Braidwood Station, Units 1 and 2
Facility Operating License Nos. NPF-72 and NPF-77
NRC Docket Nos. STN 50-456 and STN 50-457

Byron Station, Units 1 and 2
Facility Operating License Nos. NPF-37 and NPF-66
NRC Docket Nos. STN 50-454 and STN 50-455

Subject: Request for Technical Specifications Change
Expanded Core Operating Limits Reports

DESCRIPTION AND SAFETY ANALYSIS FOR PROPOSED CHANGES

Figure 2.1.1-1 (page 1 of 1)
Reactor Core Safety Limits

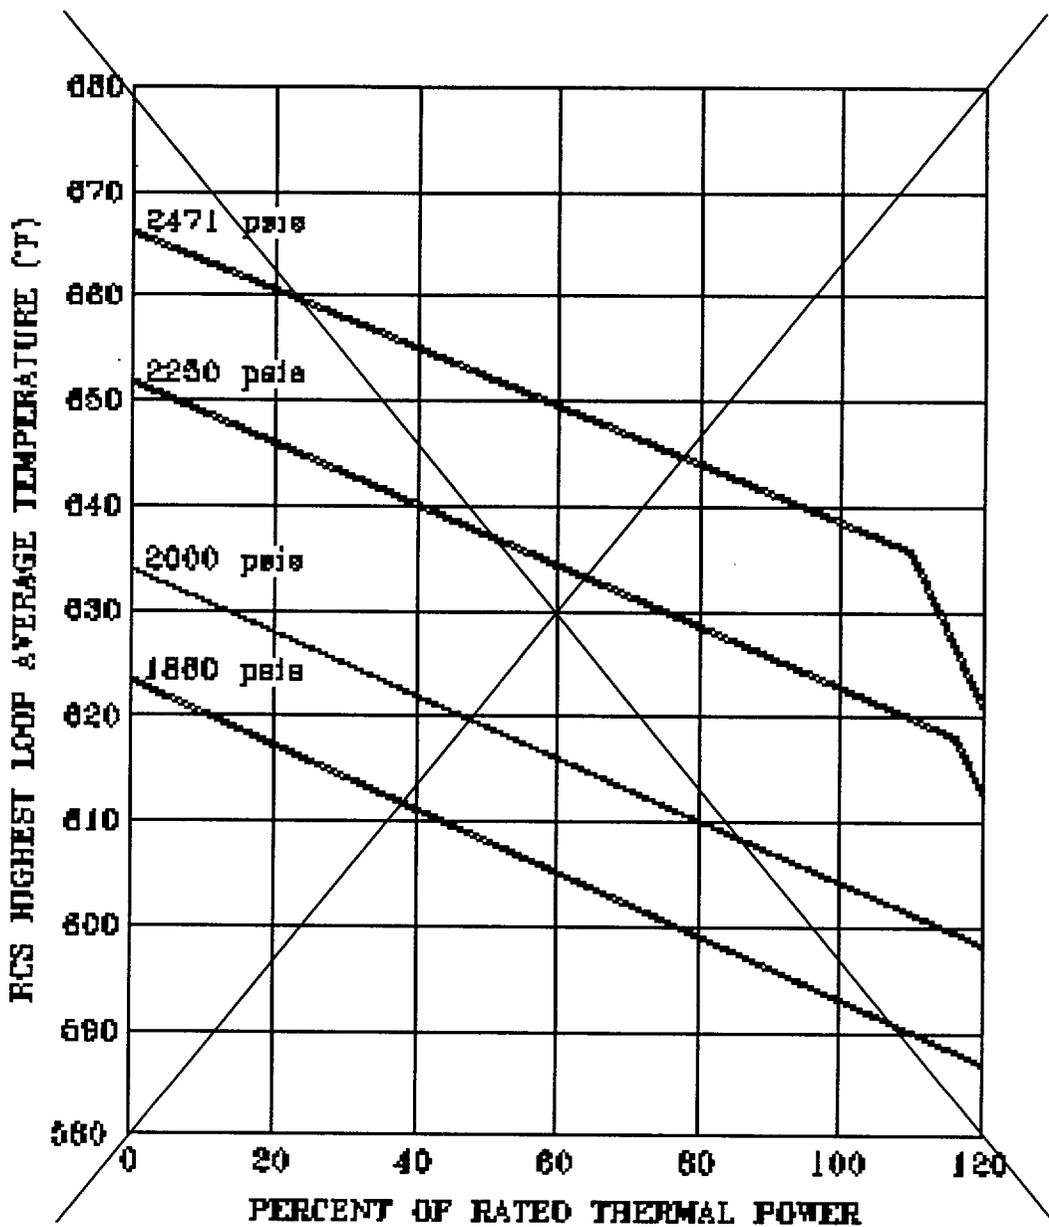
~~In MODES 1 and 2, the combination of THERMAL POWER, Reactor Coolant System (RCS) highest loop average temperature, and pressurizer pressure shall not exceed the SLs specified in Figure 2.1.1 1.~~

DELETE FIGURE

TS Figure 2.1.1-1, "Reactor Core Safety Limits," is being relocated to the COLR for each of the four units, and is being replaced with more specific fuel DNBR and peak fuel centerline temperature safety limits.

Figure B 2.1.1-1 (page 1 of 1)
Reactor Core Safety Limits vs. Boundary of Protection

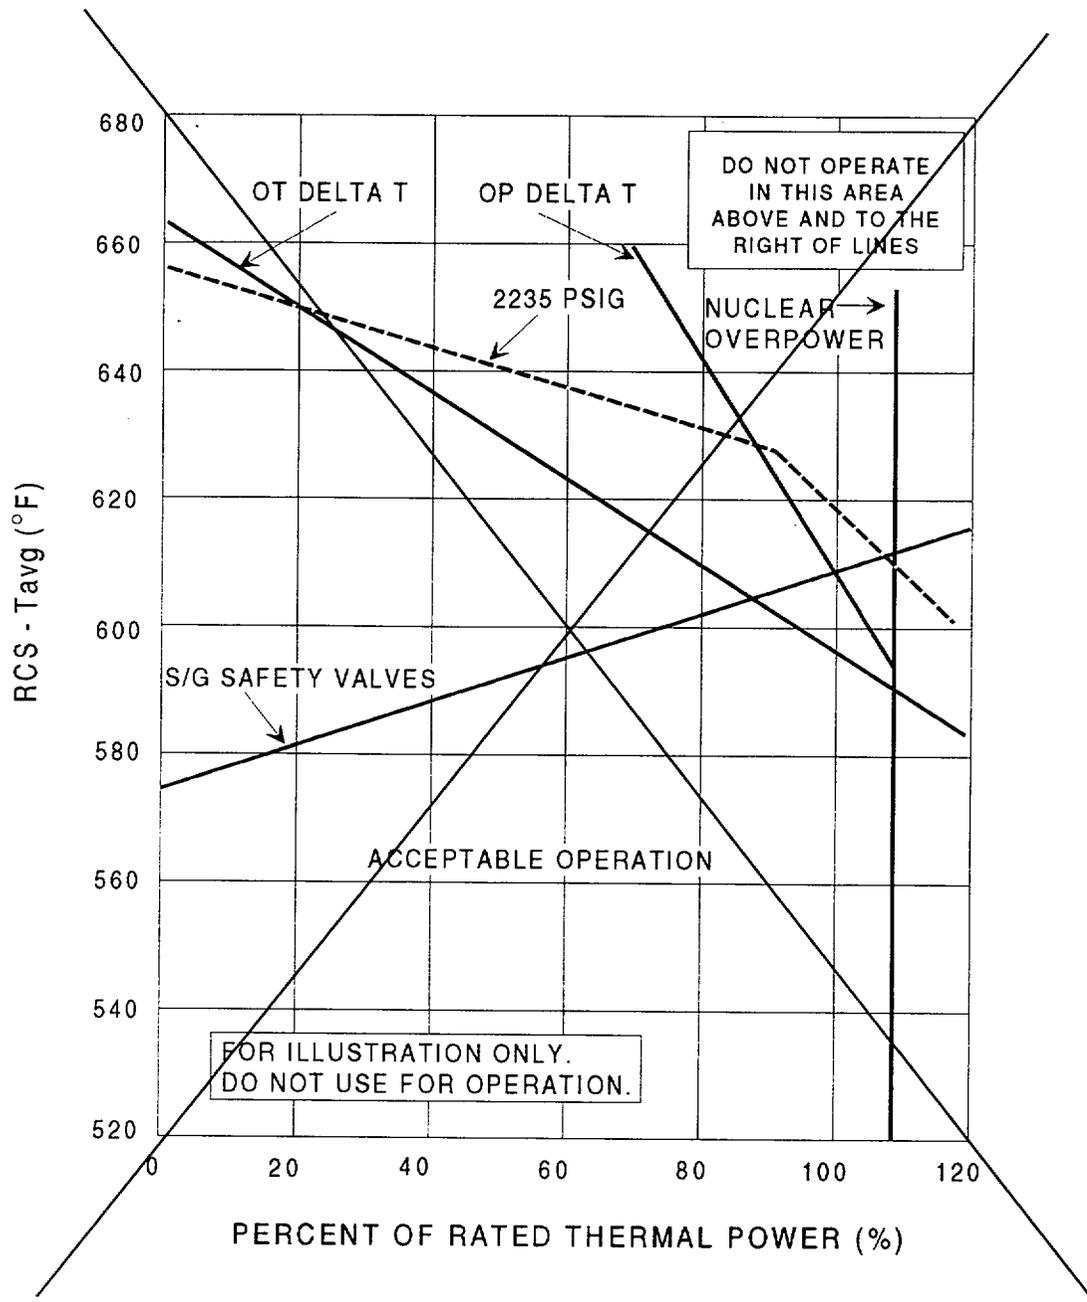
~~Figure B 2.1.1-1 shows an example of the reactor core safety limits of THERMAL POWER, RCS pressure, and average temperature for which the minimum DNBR is not less than the safety analyses limit, that fuel centerline temperature remains below melting, that the average enthalpy in the hot leg is less than or equal to the enthalpy of saturated liquid, or that the core exit quality is within the limits defined by the DNBR correlation.~~

~~The curves are typically derived based on enthalpy hot channel factor limits such as those provided in the COLR. The dashed line of Figure B 2.1.1-1 shows an example of a limit curve at 2235 psig. In addition, it illustrates the various RPS functions that are designed to prevent the unit from reaching the limit.~~

DELETE FIGURE

Figure 2.1.1-1 (page 1 of 1)
Reactor Core Safety Limits

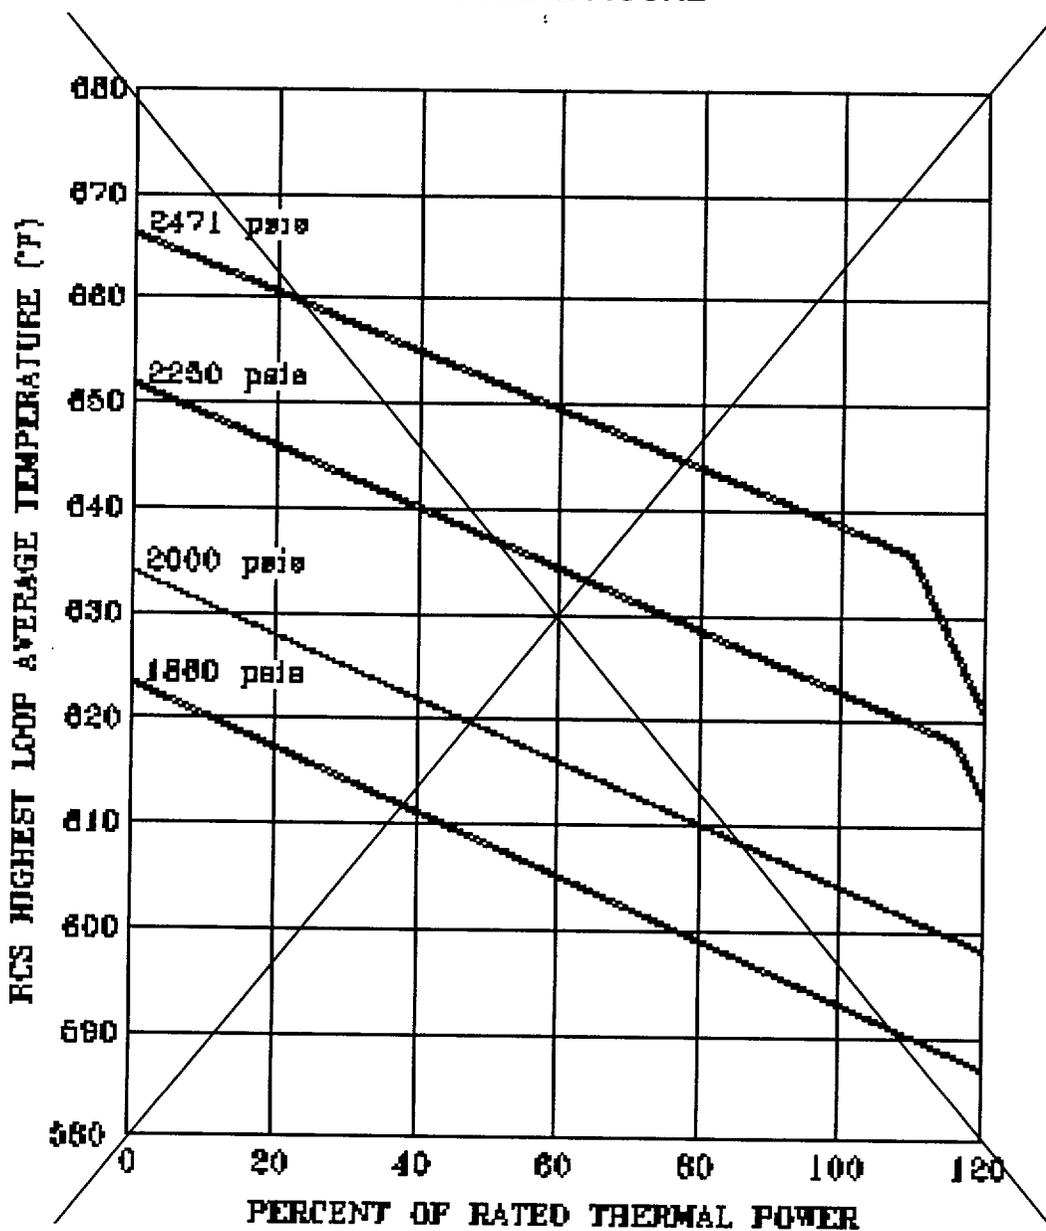
~~In MODES 1 and 2, the combination of THERMAL POWER, Reactor Coolant System (RCS) highest loop average temperature, and pressurizer pressure shall not exceed the SLs specified in Figure 2.1.1.1.~~

DELETE FIGURE

Figure B 2.1.1-1 (page 1 of 1)
Reactor Core Safety Limits vs. Boundary of Protection

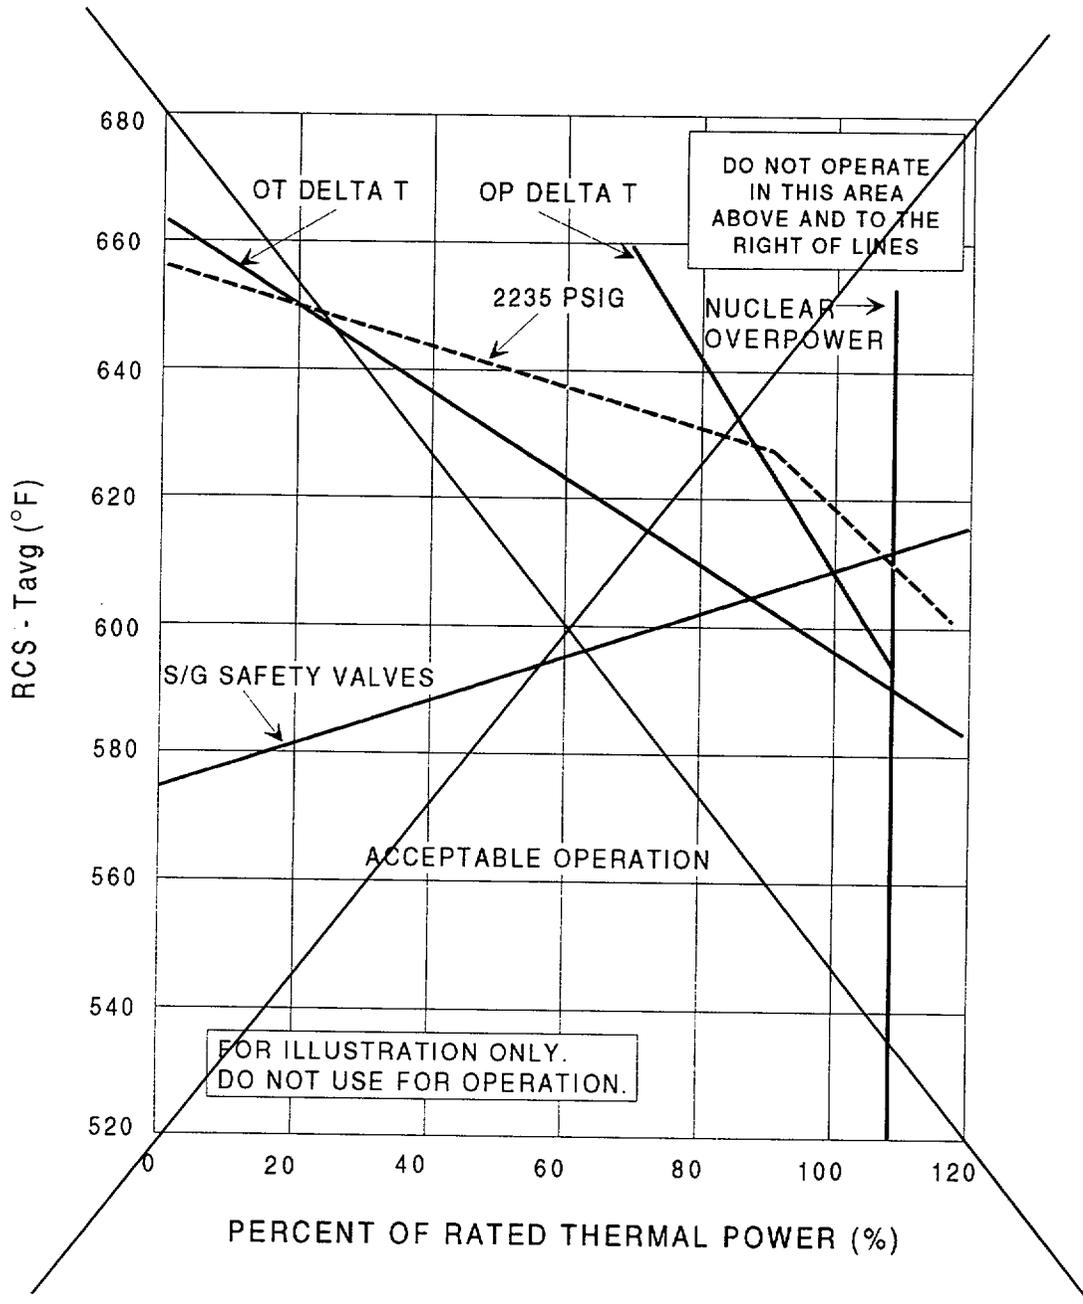
~~Figure B 2.1.1 1 shows an example of the reactor core safety limits of THERMAL POWER, RCS pressure, and average temperature for which the minimum DNBR is not less than the safety analyses limit, that fuel centerline temperature remains below melting, that the average enthalpy in the hot leg is less than or equal to the enthalpy of saturated liquid, or that the core exit quality is within the limits defined by the DNBR correlation.~~

~~The curves are typically derived based on enthalpy hot channel factor limits such as those provided in the COLR. The dashed line of Figure B 2.1.1.1 shows an example of a limit curve at 2235 psig. In addition, it illustrates the various RPS functions that are designed to prevent the unit from reaching the limit.~~

DELETE FIGURE

Figure 2.1.1-1 (page 1 of 1)
Reactor Core Safety Limits

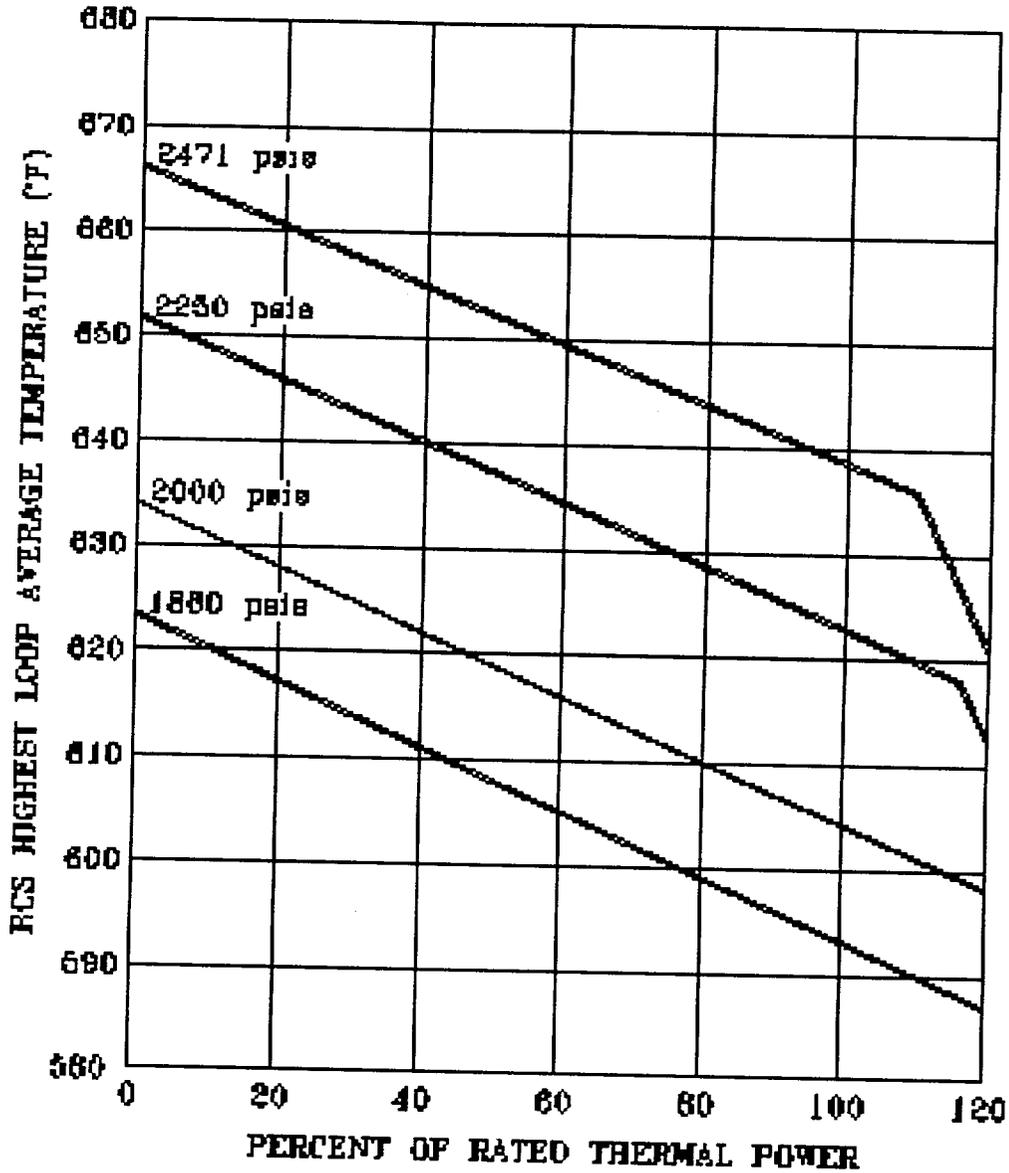
Reactor Core Safety Limits (from TS Figure 2.1.1-1)

Relocated figure
